ADDENDUM HERITAGE STATEMENT

**Former Offices at 3 York Street, Manchester
Above Browns Bar & Brasserie
1-3 York Street, Manchester, M2 2AW**

December 2023

Figure 2: Ground Floor layout of Banking Hall

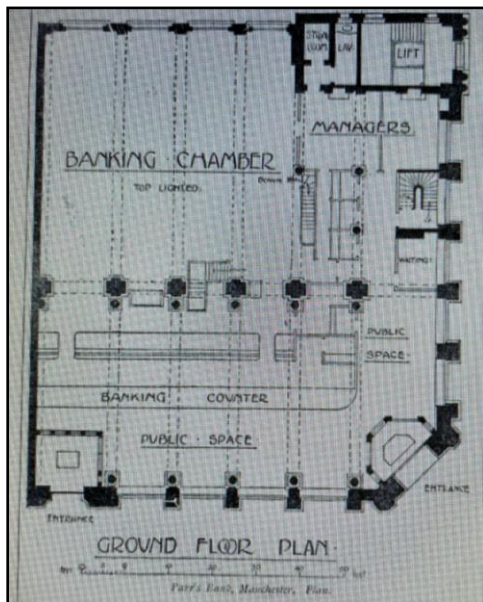
- 5.3 Heathcote's original design concept was to create two adjoining bank chambers with a ceiling height of 25 feet running throughout the entire ground floor. The Clerk's Room measured about 17m x 17m, with a ceiling height of 7.4m (24 feet 3 inches) to the underside of the ceiling light. The main curved supporting beams are set 4m apart, with panels between. The beams were encased in white fibrous plaster mouldings. Between each of the main supporting beams were pairs of glazed panels in a pattern repeated seven times; making 56 panels in total across the ceiling. The modern pyramid roof built over the area has a maximum height of 11.8m, from which the service area ceiling is supported on metal straps that pass through the open frame of the original roof (**Photo 1**).

- 5.4 The proposed new lift shaft breaks through both roofs. This will involve carefully removing one complete panel from the original glazed roof to accommodate the shaft and trimming four others, as well as a section of a main curved structural beam. All existing timbers will then be re-supported on the lift shaft.

daylight. The optimum heritage outcome is to retain and conserve the remaining remnants of leaded glazed sections (**Drawing AP41**) and display them elsewhere with an explanatory panel. This will mitigate much of the harm caused by the proposed roof timber intervention and, because the present arrangement provides a dry, stable, environment for original timbers it is intended to leave them undisturbed. An appropriate location for the display panel is proposed within the hotel.
